**Southeast Planning Review and Adjustment Committee /  
Comité de révision de la planification de la Commission du Sud-Est**

**Staff Report / Rapport du personnel**

**Subject / Objet :** L. Dysart Estate Unit 9

**File number / Numéro du fichier** 21-2192

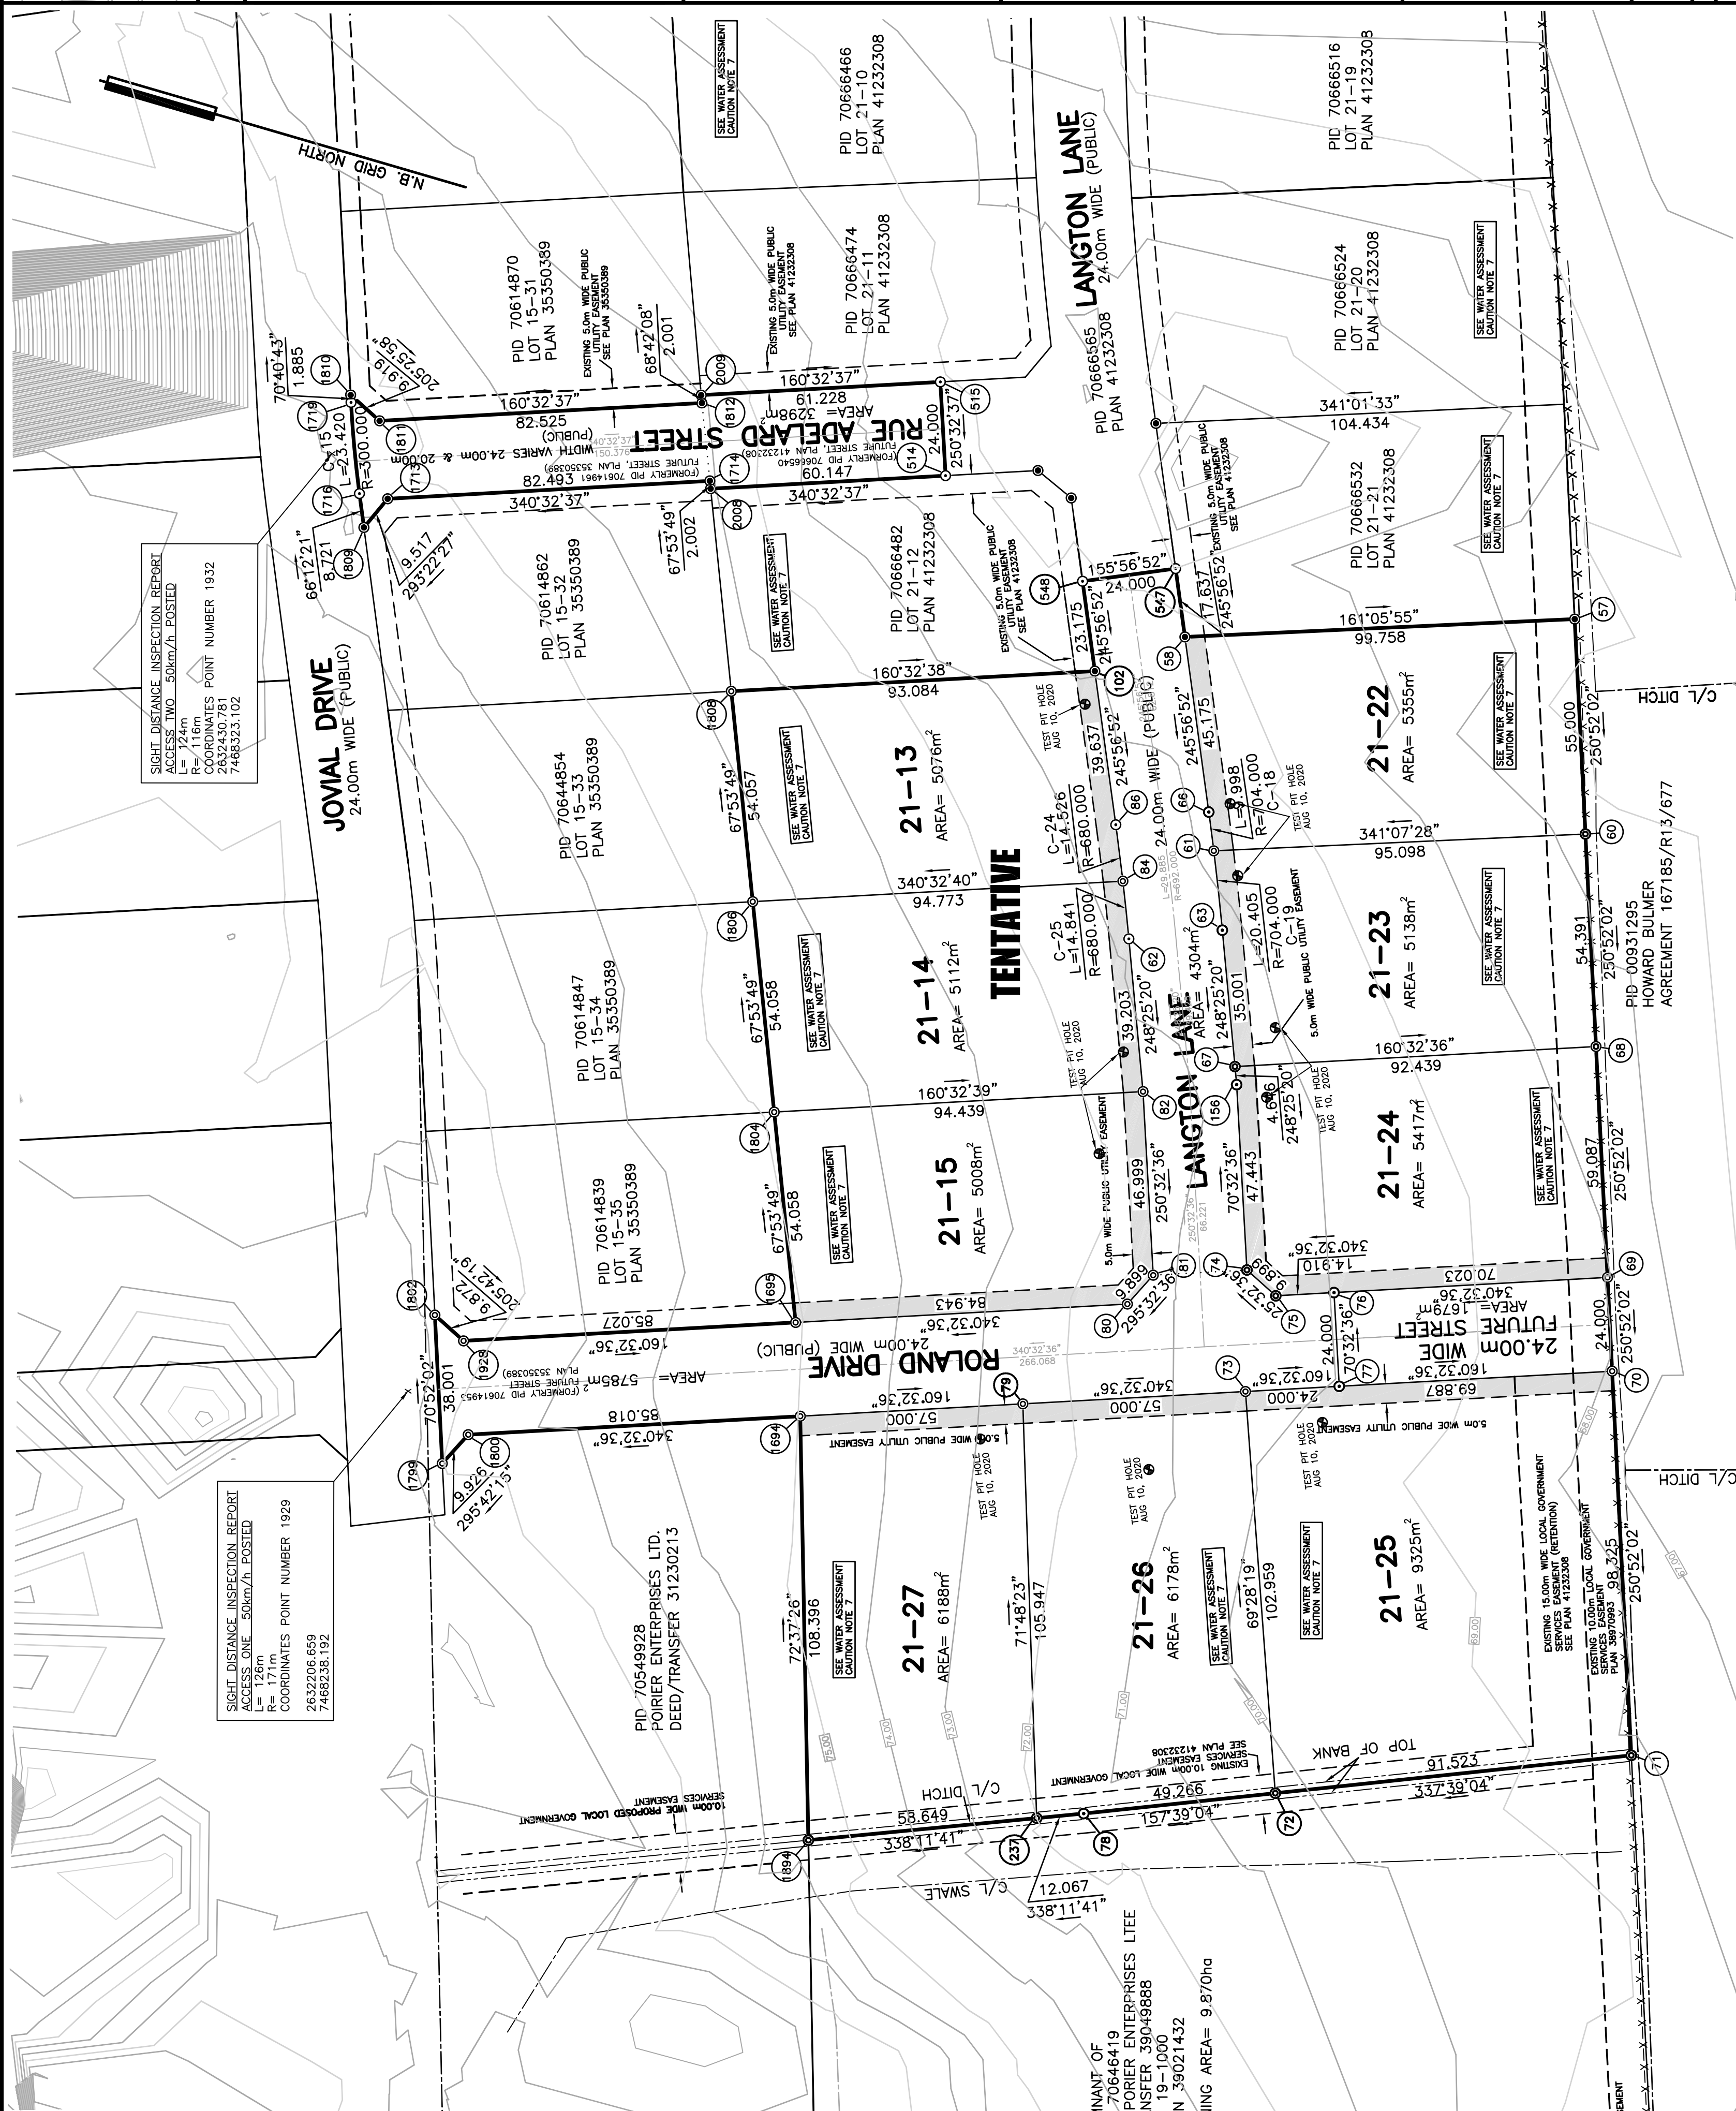
As mentioned above, the plan was sent to the Department of Transportation and Infrastructure and no specific concerns were raised. A copy of the letter from Mr. Paul Lightfoot to Mr. Jeff Boudreau dated November 12, 2021 is attached to this report. During the approval of the previous unit 8 plan a condition was included to construct the future street connection to jovial prior to registering any future units. This section of road should be included on this plan and vested as a public street / *Tel discuté, le plan fut envoyé au ministère des Transports et aucun changement n'a été demandé. Une copie de la lettre de M. Paul Lightfoot à M. Jeff Boudreau daté du 12 novembre 2021 est incluse dans le rapport. Dans la lettre d'acceptation de l'unité précédente 8, il y avait une condition que la rue future jusqu'à la joviale doit être construite avant que d'autres unités soient enregistrées. Cette section de route devrait être incluse sur ce plan.*

The location of the proposed street(s) shown on the tentative subdivision plan mentioned above are acceptable to the Department of Transportation and Infrastructure.

- The developer is required to submit a street design including a plan and profile and cross sections showing top and bottom of foreslopes and backslopes, direction of ditch flow, pipe sizes, Local Government Services Easements and street right-of-way width for the proposed streets. The design drawings must be prepared and stamped by a registered Professional Engineer of New Brunswick and submitted to the Department prior to the Minister signing the final plan.

- The drainage system shall be designed to consider the drainage basin as a whole and must accommodate not only runoff water from the subdivision area but also, where applicable, the system shall be designed to accommodate the runoff water from those areas adjacent to and upstream from the subdivision itself, as well as its effects on lands downstream. It is the developer's responsibility to determine how the run-off water from the lots and the proposed public streets will be carried away to ensure that it does not have a negative effect on the proposed lots and the existing properties in the area. A detailed drainage report must accompany the drainage plan in order to evaluate the drainage pattern. Where environmental permits are required, copies should be forwarded to the Department of Transportation and Infrastructure. Prior to the Minister signing the final plan, stamped copies of the engineered drainage study and design shall be forwarded to the Department.

- The developer shall provide "Local Government Services Easements" with a 10-m minimum width for all drainage ditches crossing the proposed lots and the remnant property that are intended to drain water to and away from the street ditches in the proposed development. The minimum grade for drainage ditches is 1.0%.

- The right-of-way limits at the proposed street intersection(s) shall be laid out as shown on "Figure A10" of the Minimum Standards.
- A suitable turning area must be constructed at the end of any temporary dead-end street created by developing the subdivision proposal in phases. The temporary turnaround must meet the requirements shown in "Figures A4 or A5" of the Minimum Standards.

- Additional street right-of-way allowance will be necessary where the topography of the land or the soil type requires extra width for deeper or wider ditches. The street right-of-way may have to be widened to more than the minimum 24 metres in some areas to ensure that the ditch and the backslope/foreslope are within the area to be vested in the Crown as a public street. The additional street right-of-way width will be necessary for future street maintenance activities. Standard survey markers shall not be placed in the ditches.

- The street(s) shall be constructed so that there are acceptable sight distances at all driveway accesses and street intersections as per 4.3.7 of the Minimum Standards.
- The turn(s) along the proposed street(s) shall be designed as curves as specified in "Section 5.2.1" of the Minimum Standards. The back-to-back curves shall be separated by a minimum tangent length of 15 m as specified in the Urban Supplement to the Geometric Design Guide for Canadian Roads produced by the Transportation Association of Canada.

Staff respectfully recommends that the Southeast Planning Review and Adjustment Committee recommend to the Minister the location of the Langton Lane and Roland Drive extension as well as Adelard street as shown on the L.Dysart Estate Unit 9 Subdivision plan dated September 26, 2021/ *Le personnel recommande que le Comité de révision de planification Sud-Est recommande au ministre l'emplacement du prolongement de la rue Langton et Roland Drive, ainsi que la rue Adelard telle démontrée sur le plan de*

**1.** The development officer shall not approve the final subdivision plan until all conditions as outlined by the Provincial Department of Transportation and Infrastructure letter from Mr. Paul Lightfoot to Mr. Jeff Boudreau Dated November 12 2021, have been satisfied. / *L'agent d'aménagement ne doit pas approuver le plan de lotissement définitif avant le respect de toutes les conditions décrites par le ministère provincial des Transports et de l'Infrastructure dans la lettre de M. Paul Lightfoot à M. Jeff Boudreau (envoyée le 12 novembre 2021).*

**2.** A soil assessment report shall be sent to the development officer prior to the final plan endorsement. / *Il faut envoyer un rapport d'évaluation du sol à l'agent de développement avant l'approbation du plan définitif.*
